Remediation of the Moab Uranium Mill Tailings, Grand and San Juan Counties, Utah, Final Environmental Impact Statement

July 2005

**Volumes III
Chapters 1-3
Comment Responses**

**U.S. Department
of Energy**

Figure 1

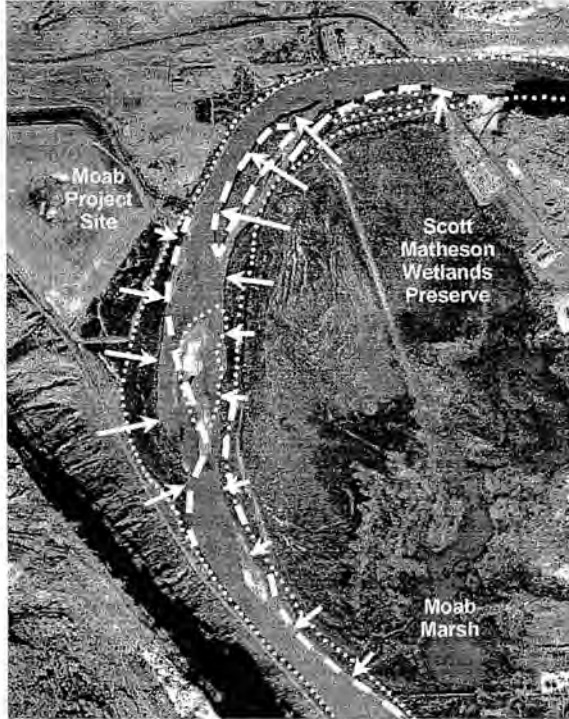
By accurately registering all the historic maps and photographs, reliable comparisons between one time and another can be made, and the picture summarized in Figure 1 emerges clearly. Since 1924, the south and east bank (river left) has moved progressively north, west and southwest away from Moab. From the bridge to the pile, the south bank has moved north and northwest an average of 320 feet since 1944. Downstream from the pile, this bank has moved west and southwest an average of 175 feet during this same period. In contrast, most of the north and west bank (river right) has remained in essentially the same position since 1924. The only significant exception is the area immediately adjacent to the pile where the channel appears relatively unstable. In this area, the west bank shifted rapidly eastward between 1962 and 1983, only to shift westward again sometime before 2001. The net result of all of these changes has been a conspicuous 37% narrowing of the channel that occurred mostly between 1962 and 1983.

However, as inspection of historical aerial photographs clearly shows, the Colorado River channel has, in fact, moved more than 300 feet north and northwestward between 1944 and the present time (Figure 1). In direct contradiction to DOE's argument, most of this movement occurred directly opposite and immediately downstream from the mouth of Courthouse Wash.

Figure 3

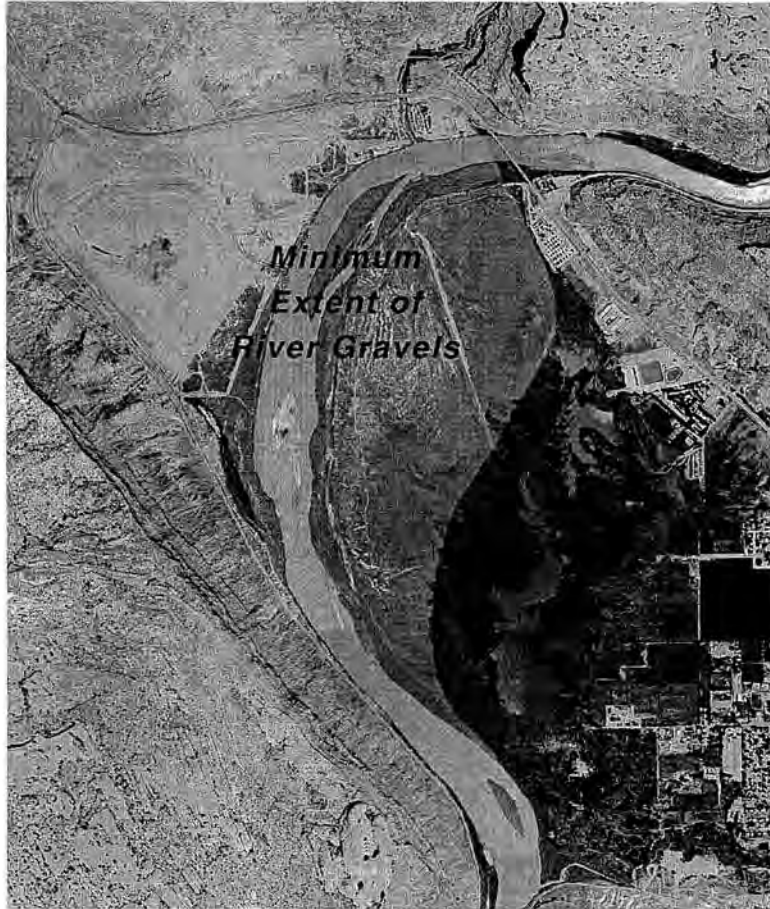
Of more significance is the fact that similar river gravels are widely distributed beneath the surface of Moab Valley (Figure 3) demonstrating that the Colorado River channel has, in the past, flowed directly through the site of the tailings pile.
